Remarks:

Fig. 1

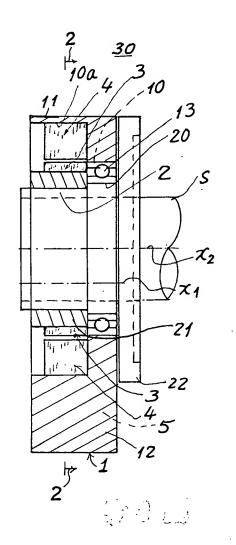
3. For Drawing objections:

- (A) For the "multiple-pole magnet" as presented in the Claims has now been amended to be "magnet" to overcome the rejection/objection on the Drawings. Since the magnet (3) and the electromagnetic coil (4) are conventional or wellknown elements, their detailed structures are thus not shown in the drawings. Still, the hatch lines showing the magnet (3) and coil (4) are now canceled, and are partially substituted with few shading lines therefor. A set of Replacement Pages of corrected drawings is enclosed herewith for the Examiner's further approval.
- (B) Claim 5 is currently amended to cancel "rectifying circuit" and "lens" to overcome the drawing rejection.
- 4. For Claim 2, "the shaft of the driving motor" has its antecedent basis already presented in the amended Claim 1, Line 4, namely "a sleeve adapted to be secured on a shaft of a driving motor....".
